COLUMBIA COUNTY
NORTH FLORIDA MEGA INDUSTRIAL PARK (NFMIP)
WASTEWATER TREATMENT FACILITY (WWTF)
BID NO. 2022-1

Jones Edmunds Project No. 03780-001-01

ADDENDUM NO. 4

Wednesday, May 4, 2022

**SHEET M19 (REVISED) WITH GOPHER TORTOISE
LOCATIONS**

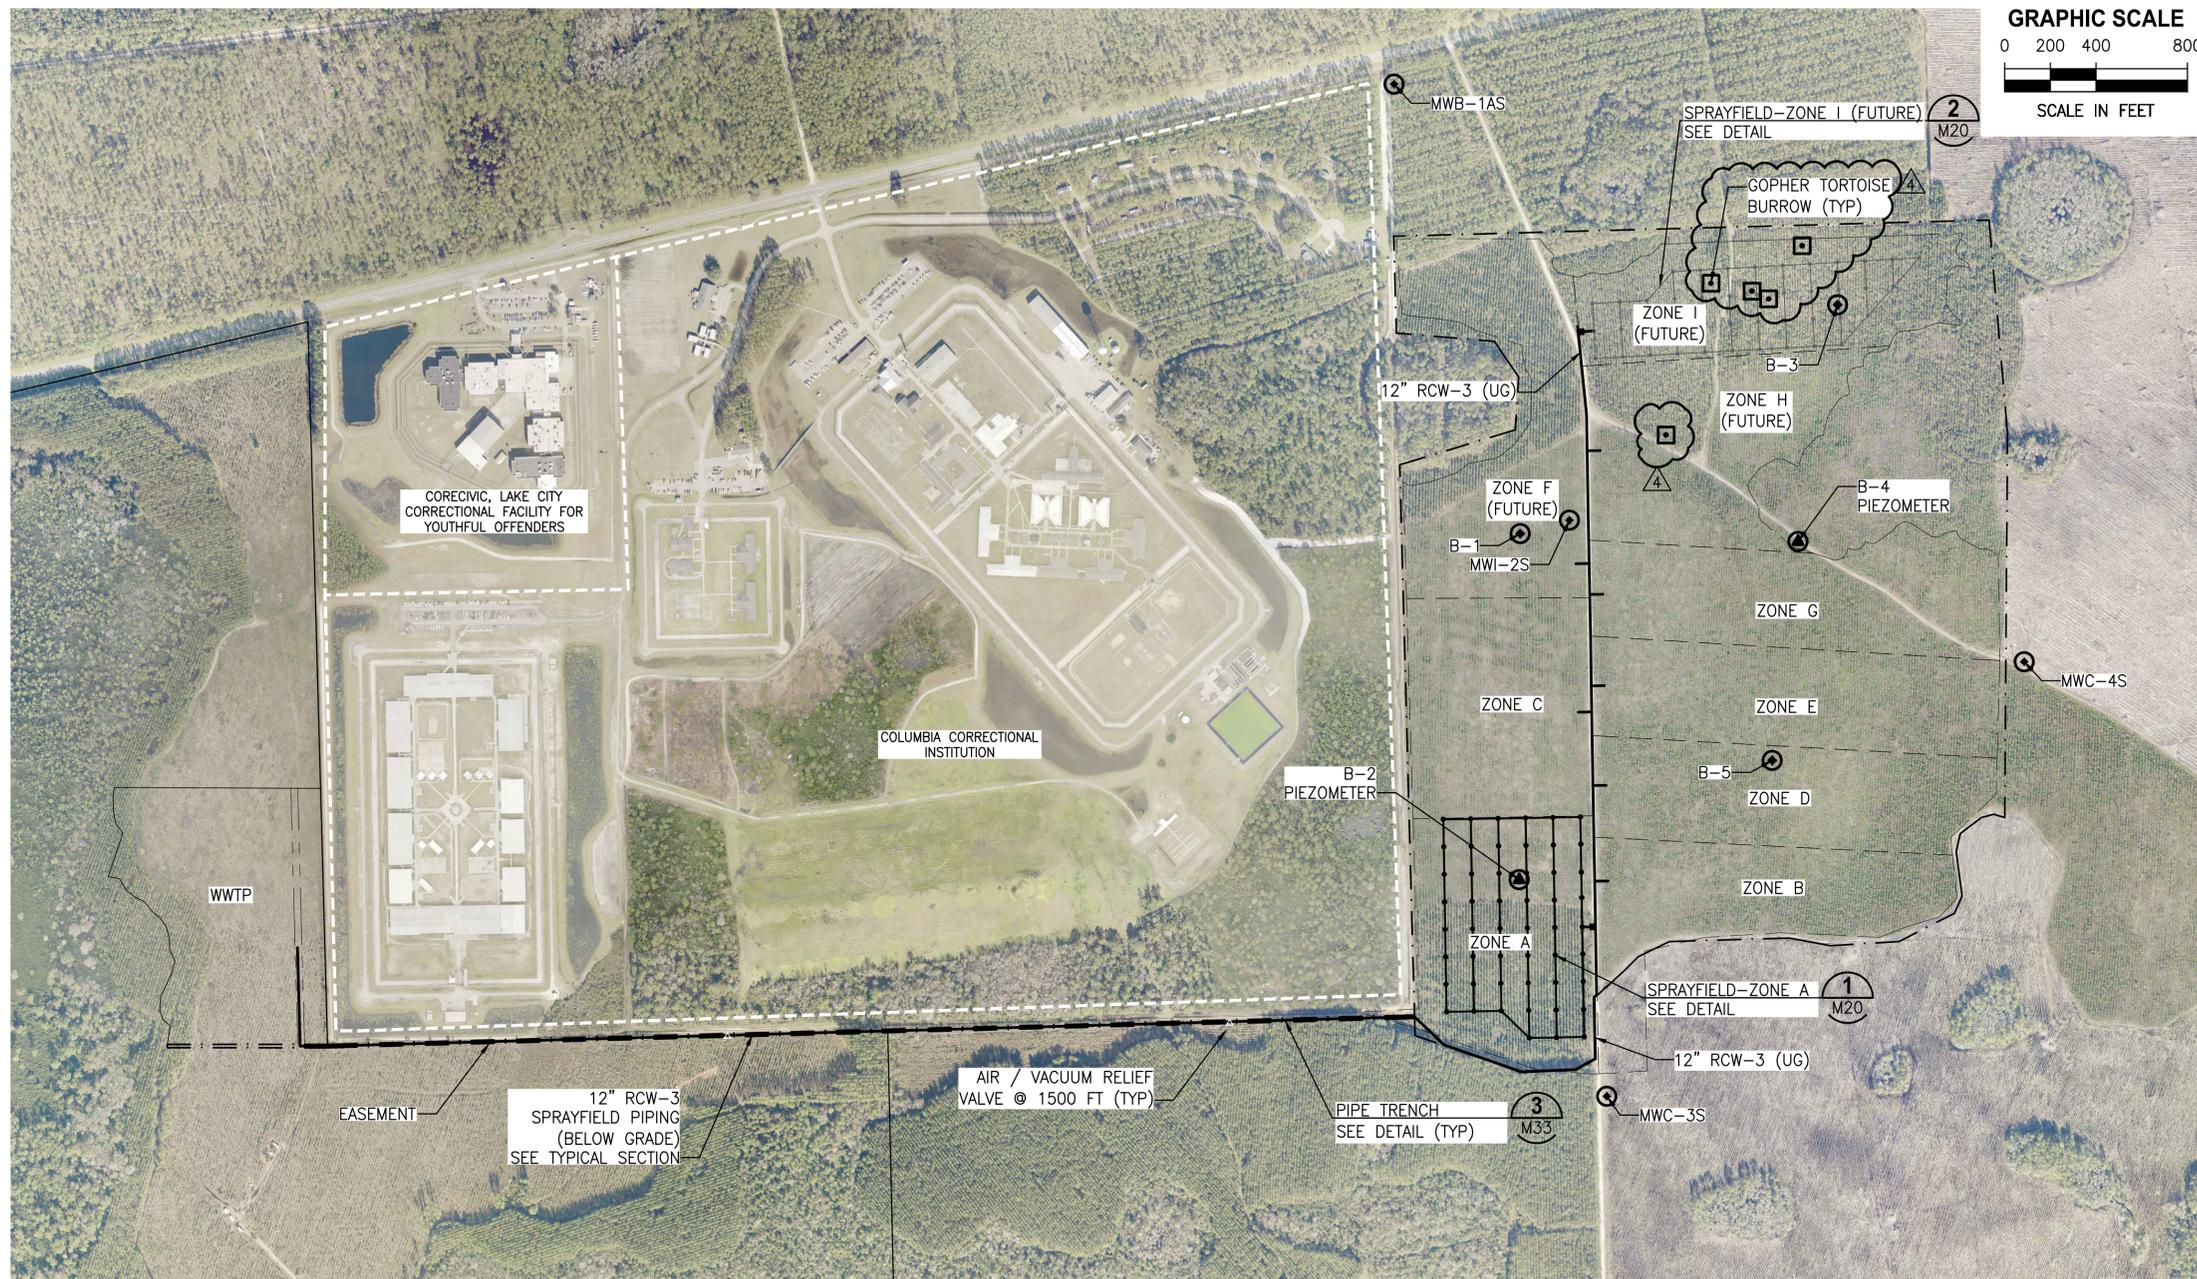
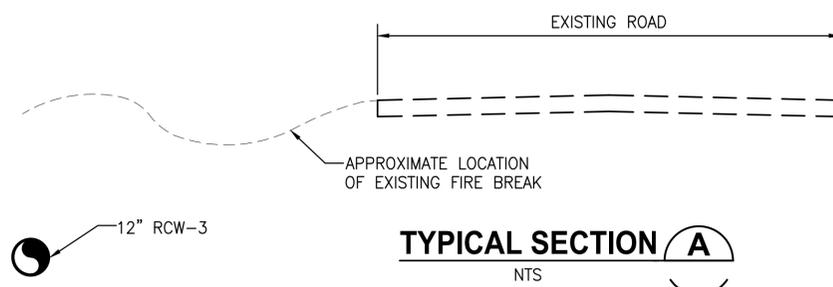
- Q9. REF: Sheet M20, Note 9D – This note mentions gopher tortoise locations are shown on Sheet M19. We can not find these. Confirm if the contractor will be responsible for gopher tortoise relocating.*

- A9. Sheet M19 was reissued (See Attachment C) showing gopher tortoise burrow locations. The intent is to not disturb these burrows during sprayfield construction. Gopher tortoise relocation is not required as part of this Contract.**

OFFSET AIR VALVE DETAIL 2
NTS

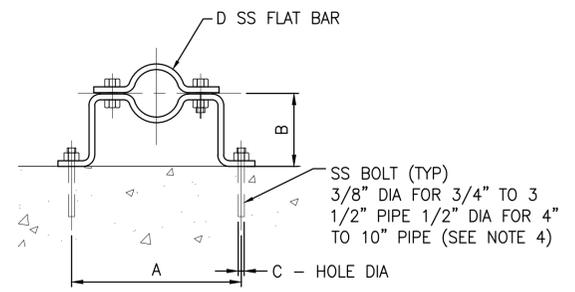
- Q11. REF: Sheet M19 and C16 – Furnish a detail for the air/vacuum relief valve assembly and containment structure.*
- A11. See Detail 2 on reissued Sheet M32 (See ATTACHMENT D). The ARV Enclosure shall be color Pantone Purple or equivalent for reclaim water.**
